Access Compliance Report

Public Rights-of-Way

(Pedestrian Signals)

Intersection ID: N/A	Main Street:	Cross Street: N/A	Location: N/A
ADA ID: FE282FD7ED3F	Signal Type: Two Push Buttons-APS	Overall Compliance: No	Severity Score: BTN 1:N/A BTN 2: N/A No BTN: N/A
Codes/Mitigation Info/Possible Solution		Field Measurements/Component Compliance

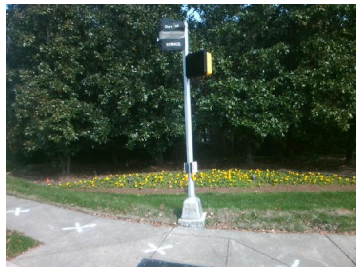
Surveyor Notes: B2 OUT OF SERVICE

PROW/ADA: TMUTCD 4e.08, R404.2, R404.3, R209.1, TMUTCD 4e.10, MUTCD 4e.08, R104.2

Possible Solutions: Replace Signal Push Button With APS Button on New Post. Remove & Relocate Sign.
